# Product Change Notification

Product Group: OPT/Wednesday December 17, 2025/PCN-OPT-1469-2025-REV-0

## New emitter LED and bonding type improvement on IGBT and high speed optocoupler

# Emitter LED and Bonding Type PCN OPT-1469-2025

## Forward Voltage vs. Forward Current

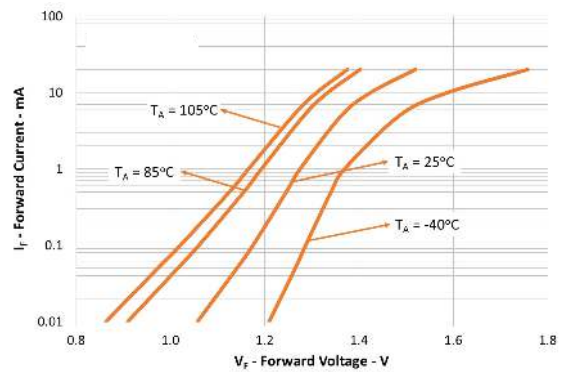
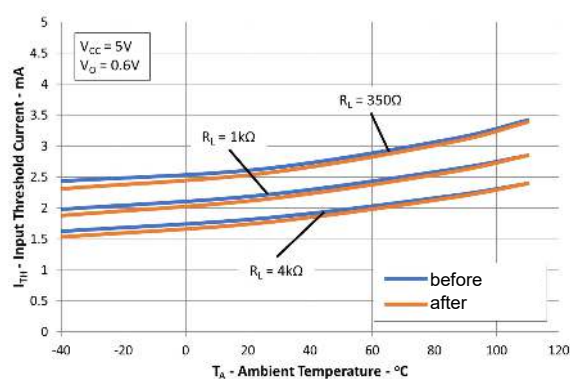
**Description of Change:** The emitter chip currently used in 1 Mbd and 10 MBd high speed and IGBT driver optocoupler has been discontinued. The emitter chip will be replaced with an technically equivalent one. The bonding type will be standardized to BSOB reverse bond.

**Expected Influence on Quality/Reliability/Performance:** Some characteristics, typical and maximum values of the 1 MBd high speed coupler VOH1016A will be adapted to the new emitter chip. Other parameters will stay the same. No other influence on quality, reliability and performance expected. Nevertheless, we request our customers to test the product in their specific application.
